Ref: 6129

RESPONSE TO THE INTERIM DECISION ON PLAN CHANGE 62

Leeston Plan Change

Appendix 1: Revised ODP covering the deferred land only.

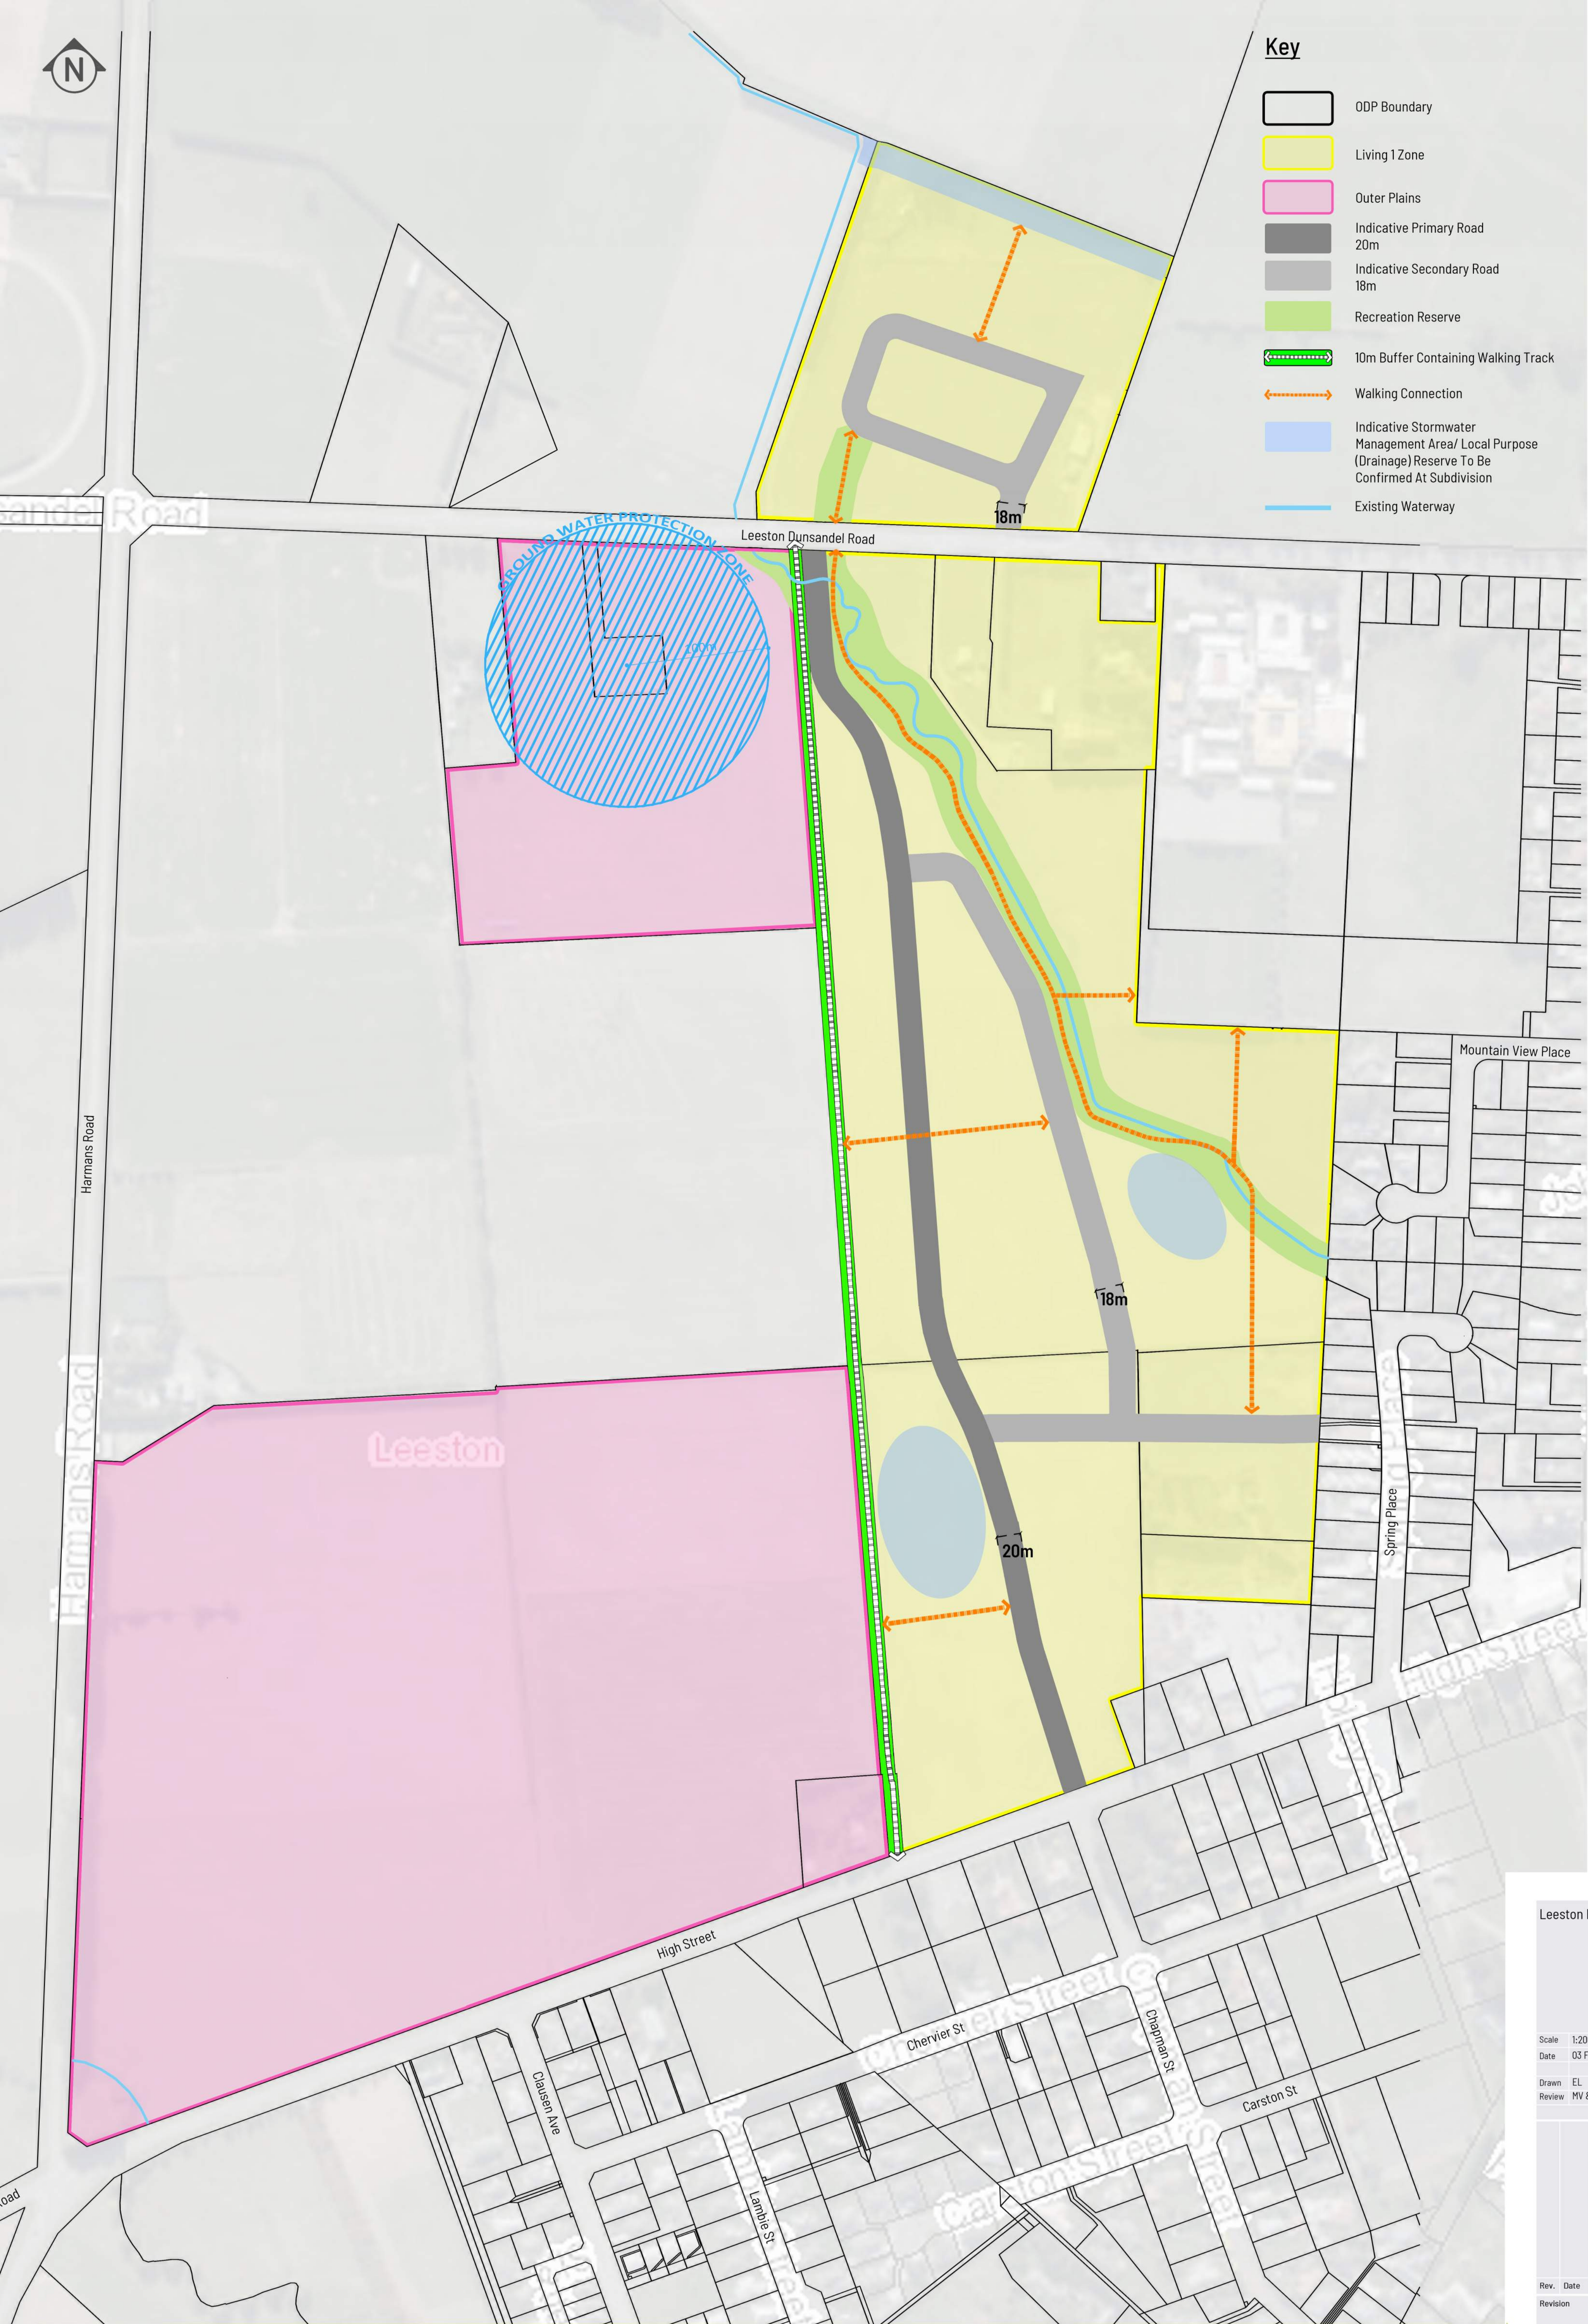
- Option 1 provides for development within the deferred zones only (Appendix 1). It is proposed to allow for a 920-metre-long buffer strip along the Living 1 and Outer Plains interface, providing a minimum of 9,200 m² of separation between the zones. The road alignment has been adjusted to accommodate an appropriate building setback for residential sections which adjoin the Outer Plains zone. This will result in larger sections adjoining the Outer Plains interface which increase the amenity of these sites and reduces the potential for reverse sensitivity.
- Option 2 provides the same layout as Option 1 but shows the stormwater basin located within the Outer Plains zone.

To allow for the 20-metre 'no build' setback, the 20-metre-wide primary spine road (between Leeston Dunsandel Road and High Street) has been shifted to the east to accommodate larger residential allotments within the Living 1 zone between the road and the Outer Plains zone. The primary spine road will maintain its alignment with the intersection of High Street and Chapman Street.

Option 1 indicates the stormwater basin within the Living 1 zone. The size and location of the basin would reduce the overall capacity of the residential zoned land but could contribute to the separation between the Outer Plains zone and the Living 1 zone.

Appendix 2: Revised ODP with Stormwater in Outer Plains

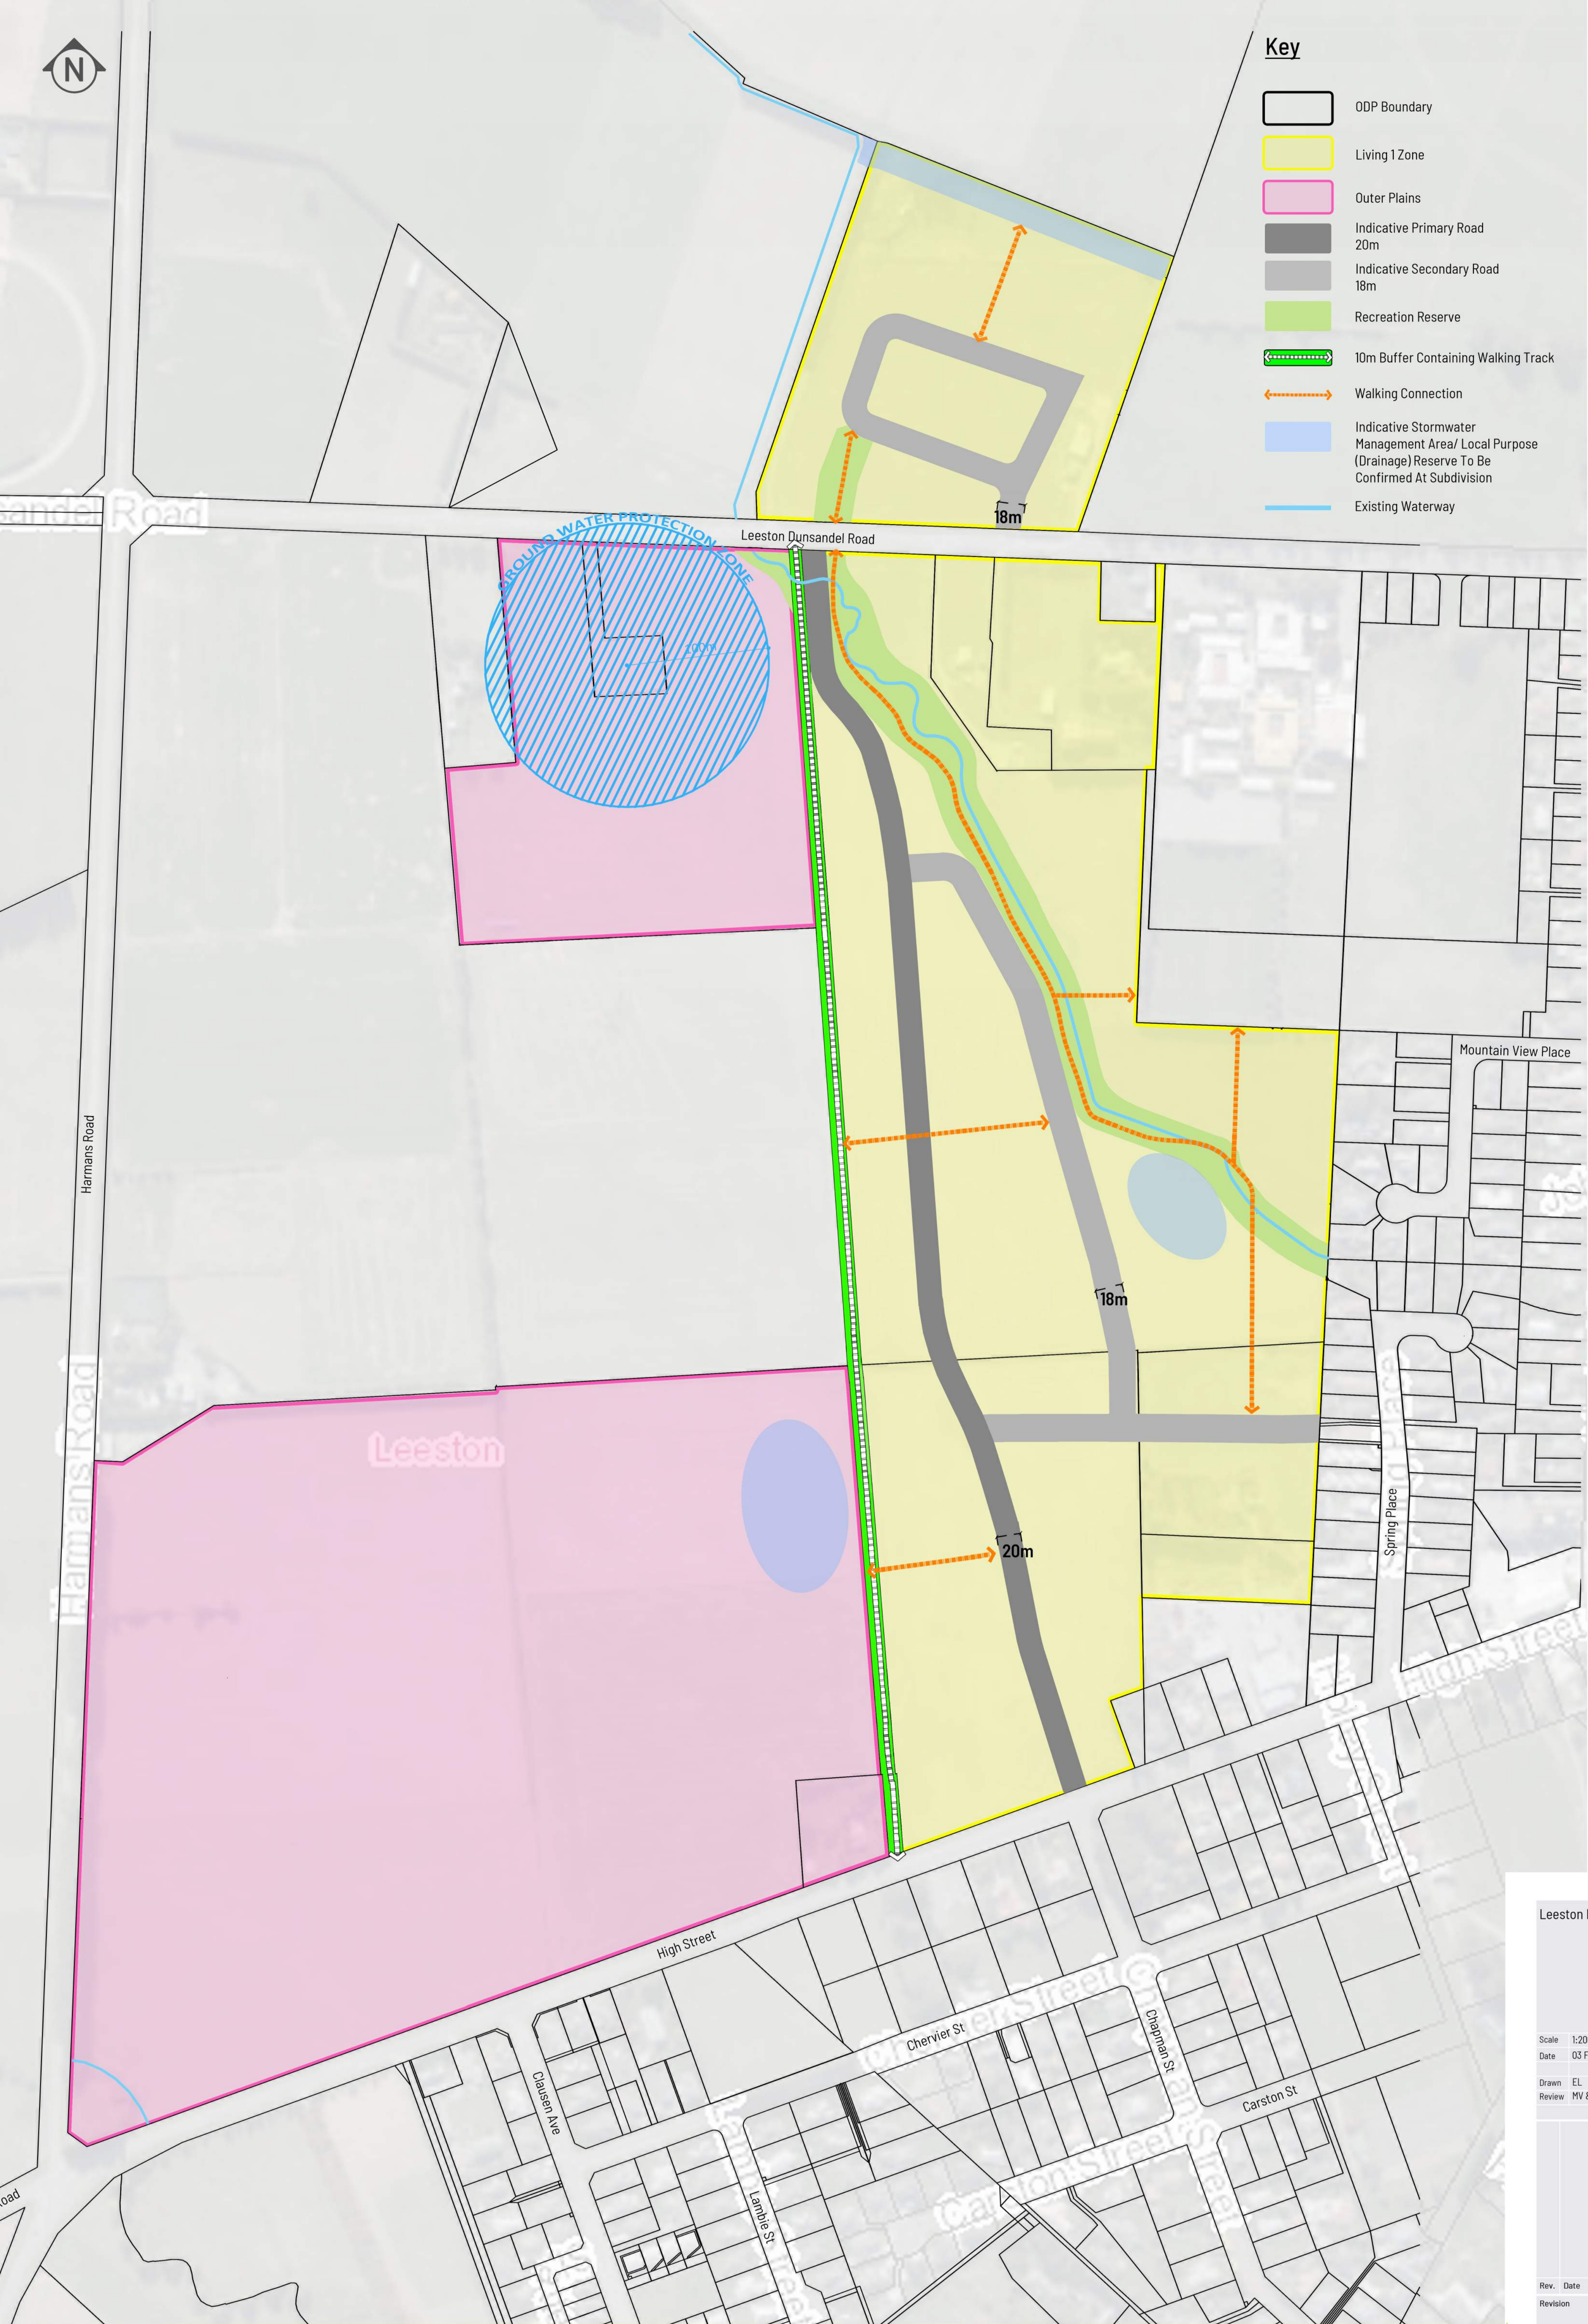
Option 2 indicates the stormwater basin within the Outer Plains zone. The option allows for the residential zone to be used most efficiently and would allow for an increase in separation for the rural / urban interface. In the event that the land between the ODP area and Harmans Road is rezoned at some stage in the future, it would also be possible to expand the stormwater area in this location to provide a single facility to service the wider area.
